# PHY transmitter block error ratio

Draft 1.3 comment #8

Matt Brown, Alphawave Semi

Figure 174A-4—Test configuration for a PHY using PCS counters

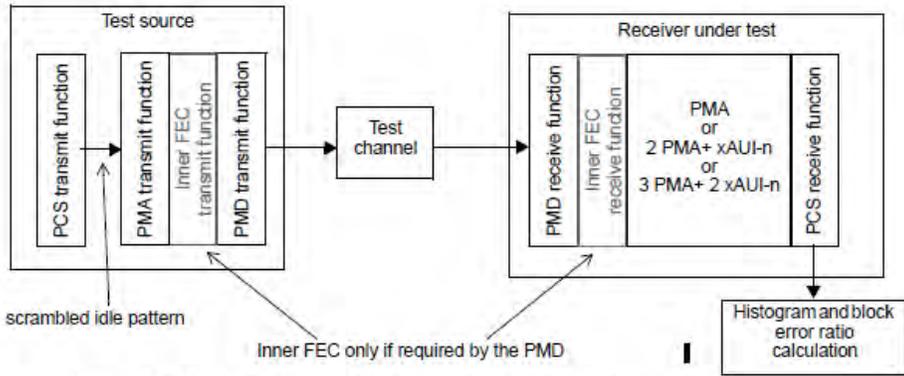
174A.7 provides a test methodology to constrain the error contributions from a PHY receiver.

A similar approach can be adopted for measuring and constraining the error ratio at the PHY transmitter.

Figure 174A-x—Test configuration for a PHY transmitter

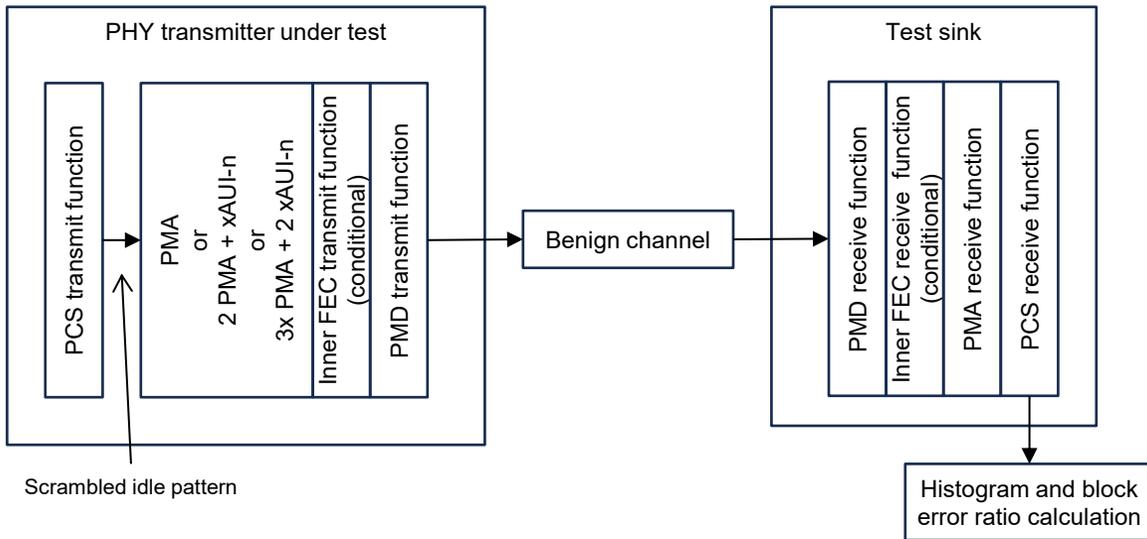
A test for a PHY transmitter can be defined largely based upon the test for the PHY receiver.

The figure to the left may be added to represent the test configuration for a PHY transmitter. The method below can be added for measurement of block error ratio for a PHY transmitter.

## 174A.7.1.5 PCS block error ratio test method for PHY transmitter

The following method is used to calculate the block error ratio for a PHY transmitter using FEC bin counters provided in the PCS.

- Measure the error histogram  $H_m(k)$  using the method defined in 174A.7.1.3.
- Calculate the histogram  $H_a(k)$  for the added BER using Equation (174A-3) with  $BER = BER_{added}$ .
- Assign the result of Equation (174A-5) and Equation (174A-6) to  $H_m(k)$  substituting  $H_m(k)$  for  $H_x(k)$  and  $H_a(k)$  for  $H_y(k)$ .
- The measured block error ratio is equal to  $H_m(16)$ .

The measured block error ratio is expected be less than  $1.45 \times 10^{-11}$ .
